PROOF OF EVIDENCE

CAMBRIDGE CITY COUNCIL

DAYLIGHT, SUNLIGHT & OVERSHADOWING

**ADDRESS: BEEHIVE CENTRE, COLDHAMS LANE, CAMBRIDGE,
CAMBRIDGESHIRE, CB1 3ET**

Image 1 – Mirror massing of St Matthew's Gardens onto the Beehive site

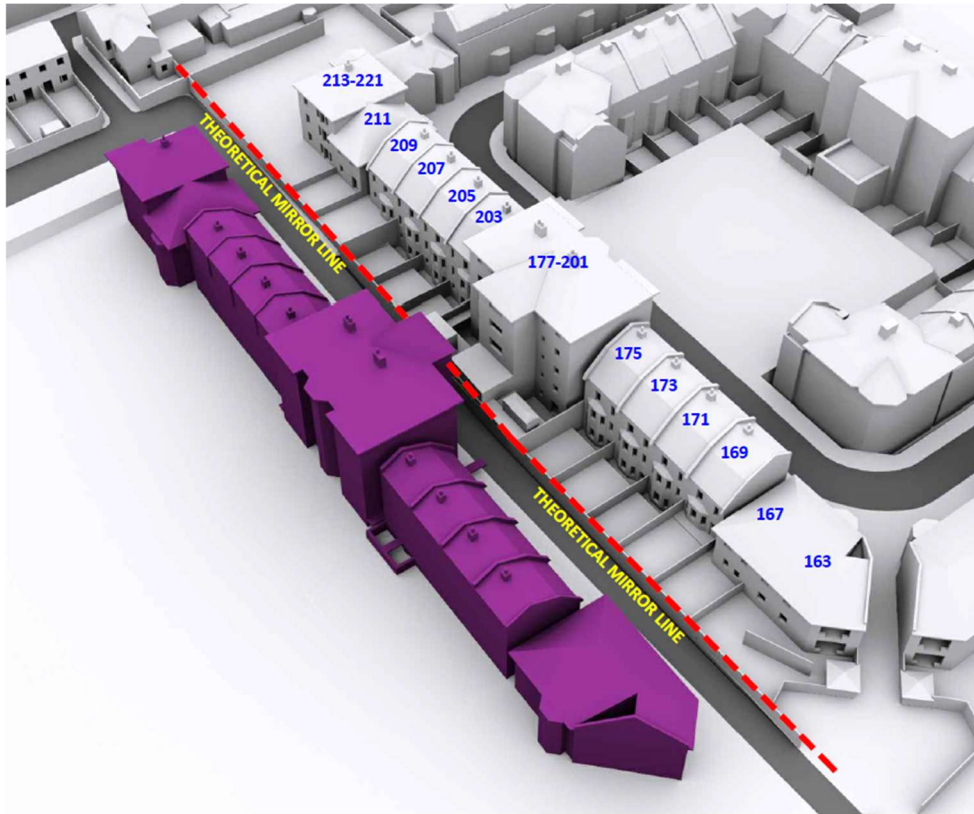
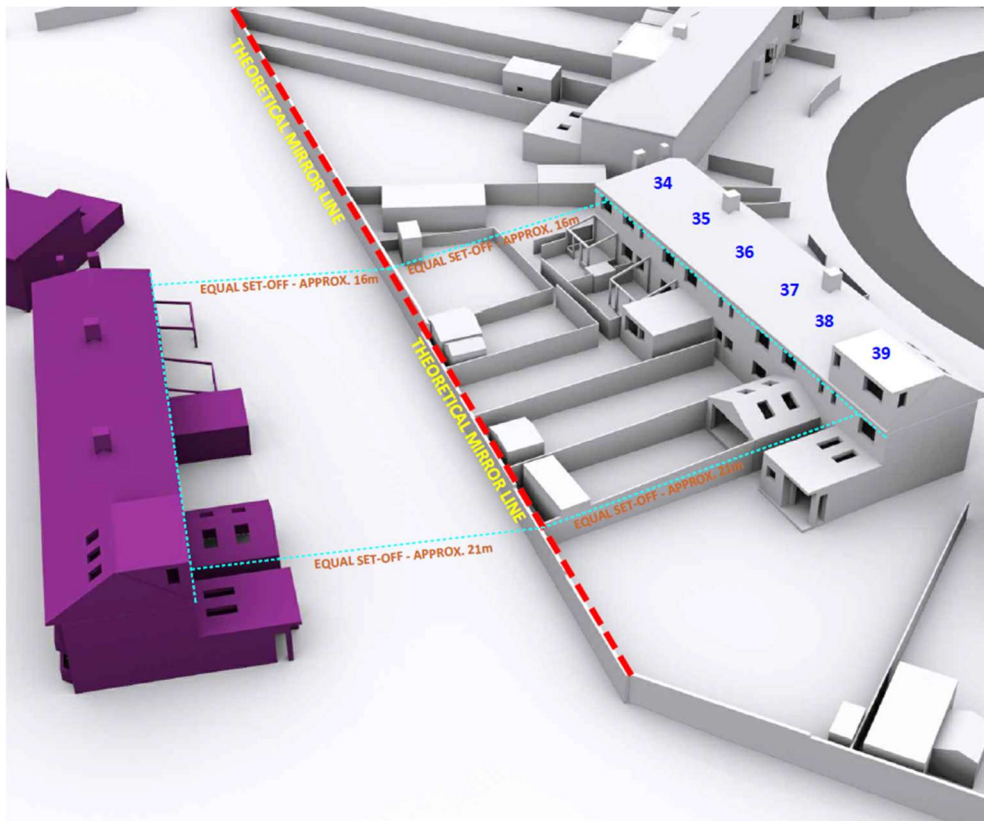
7.15 This theoretical approach substitutes the Beehive proposed development massing with a 'mirrored version' of St Matthew's Gardens and also Silverwood Close respectively onto the Beehive site, to assess the equitable distribution of daylight between the respective sites. Below is an extract of Figure F3 which assists to convey this consideration;

7.16 Following the same methodology, a 'mirror' of the St Matthew's Gardens massing is placed upon the Beehive site (the end garden fencing being the boundary / mirror line) and visually presented within **Image No. 1** and additional, for Silverwood Close within **Image No. 2** as follows;

7.17 For the purpose of the ‘mirror development’ analysis review, the windows respectively within St Matthew’s Gardens and Silverwood Place are analysed with the massing of these properties which border the site reflected opposite upon the Beehive site (all other massing on the Beehive site being removed for this analysis review but all existing surrounding massing retained for context and continuity). To highlight, for Silverwood Close, Nos. 34-39 Silverwood Close has been explored as being in effect, the most relevant / closest neighbouring terrace row of houses that borders the site within Silverwood Close.

Image No. 3 – Typical layout (lower ground floor depicted – not applicable to No. 169)

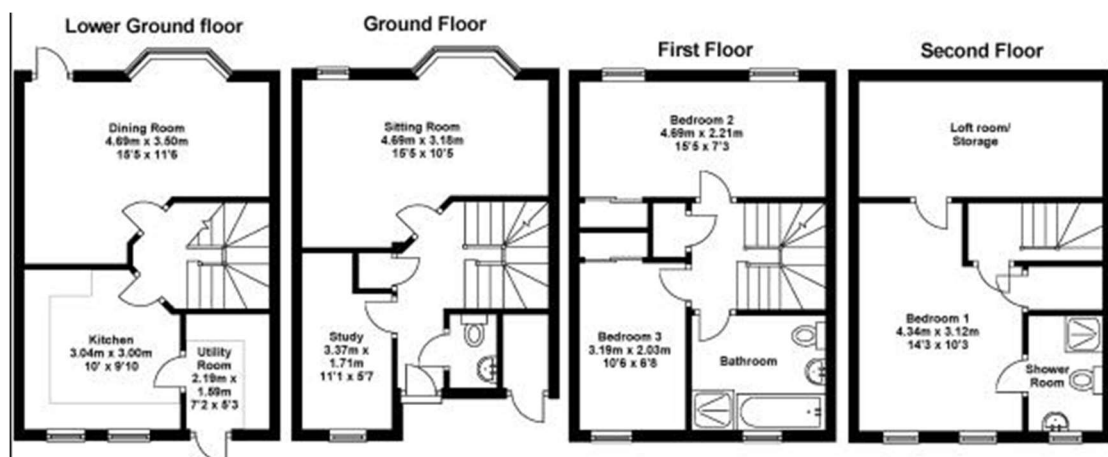
8.22 Thus, it is assumed Nos. 203, 175, 173 & 171 are the same excepting at lower ground floor for No. 175, the rear dining room and kitchen is open-plan / combined. There are no details for No. 169 (which has no lower ground floor) but at ground and 1st floor, the same rear room layouts have been assumed which is reasonable. Access for gained to Nos. 173 & 175 St Matthew's Gardens during a joint site inspection.

8.23 A typical layout is depicted in **Image No. 3**

11.0 COMMENTS ON THE ILLUSTRATIVE SCHEME IN RESEPECT OF EFFECTS TO DAYLIGHT & SUNLIGHT TO NEIGHBOURING PROPERTIES

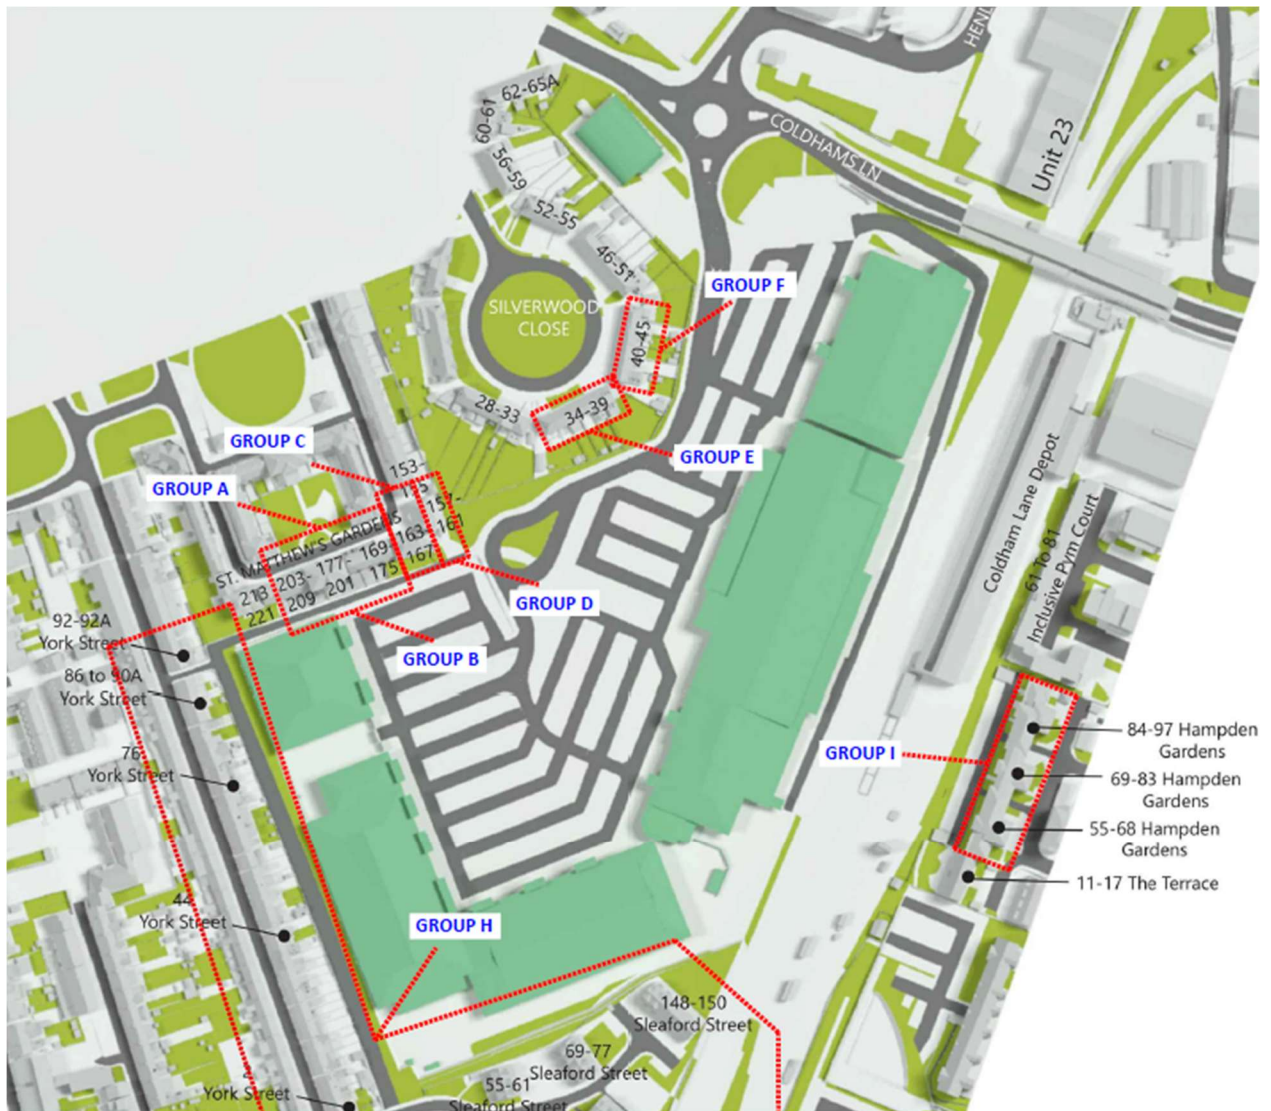
- 11.1 Whilst I have not considered in detail as to how the updated analysis (post planning) for the 'Illustrative Scheme' would translate, this would have a significantly lesser effect on the daylight and sunlight to neighbouring properties compared to the 'Maximum Parameters Scheme'.

- 11.3 However, the 'Illustrative Scheme' is not the planning application and represents just one possible massing proposal option solution that would, in effect, sit within the proposed Maximum Parameters Scheme envelope.

- 11.4 Given the level of harm to neighbouring daylight and sunlight from the 'Maximum Parameters Scheme', it does raise the question as to why the 'Maximum Parameters Scheme' has been submitted for planning permission given that clearly, the scheme has not sought to mitigate harm to the daylight and sunlight of neighbouring properties.

- 11.6 Whilst ultimately matters are for consideration in the planning balance, it is apparent that the planning application for the 'Maximum Parameters Scheme' has not sought to minimise harm, given that there is an example of a massing volume within the 'Illustrative Scheme' that presumably may potentially deliver a suitable workable proposal in terms of use order, floor space, preliminary design, viability etc that results in **less harm** (although this should not be deemed to be interpreted as acceptable harm as I have not quantified such harm in detail given that the 'Illustrative Scheme' is not the submitted planning application scheme).
